# Access Compliance Report

## Public Rights-of-Way

Intersection ID: 15195	Main Street: ALBEMARLE_RD	Cross Street: FARM_POND_LN	Location: SW
ADA ID: 8BCB9008C993	Ramp Type: Perp	Initial Pass/Fail: Fail	Overall Compliance: No
Severity Score: 8.75			
Codes/Mitigation Info/Possible Solution		Field Measurements/Component Compliance

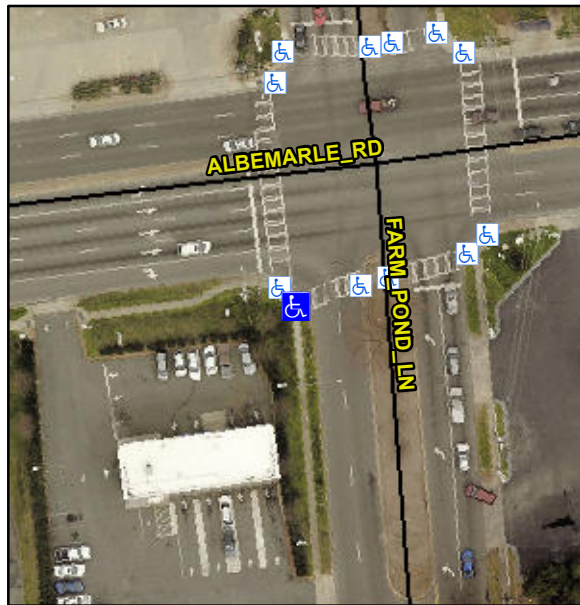
**Not Found, R304.5.1**

Compliance	Description	Data	Compliance	Description	Data
N/A	Ramp Length (in)	79.5	Yes	Ramp Slope (%)	7.3
No	Ramp Width (in)	38.0	Yes	Ramp XSlope (%)	1.8
N/A	Flare Type LT	N/A	N/A	Flare Type RT	N/A
N/A	Flare Slope LT (%)	N/A	N/A	Flare Slope RT (%)	N/A
N/A	Flare Traversable LT?	N/A	N/A	Flare Traversable RT?	N/A
N/A	Landing Length (in)	N/A	N/A	DWS Provided?	N/A
N/A	Landing Width (in)	N/A	N/A	DWS Contrast?	N/A
N/A	Landing Slope (%)	N/A	N/A	DWS Length (in)	N/A
N/A	Landing X Slope (%)	N/A	N/A	DWS Full Width?	N/A
N/A	Landing Curb? (Y/N)	N/A	N/A	DWS Offset (in)	N/A
N/A	Shared Landing?	N/A			
N/A	Gutter Ponding?	N/A	N/A	Gutter Slope (%)	N/A
N/A	Gutter Lip Ht (in)	N/A	N/A	Gutter X Slope (%)	N/A
N/A	Painted X Walk1?	Yes	N/A	Painted X Walk2?	N/A
	X Walk 1 Direction	To E		X Walk 2 Direction	N/A
N/A	X Walk 1 Width (in)	109.5	N/A	X Walk 2 Width (in)	N/A
	X Walk 1 Slope (%)	5.8		X Walk 2 Slope (%)	N/A
	X Walk 1 X Slope (%)	1.9		X Walk 2 X Slope (%)	N/A

N/A	Ramp inside XWalk1?	Yes	N/A	Ramp inside XWalk2?	N/A
	Road Slope (%)	N/A	N/A	Clear Space?	N/A
	Road X Slope (%)	N/A	N/A	Clear Space to XWalk (in)	N/A
N/A	Any Obstructions?	N/A	N/A	Storm Grate/Utility Hazard?	N/A
	Obstruction Type			Storm Grate/Utility Type	
		N/A			N/A
		Yes		Surface Condition? (G/P)	Good

**Remove & Replace Entire Ramp.**
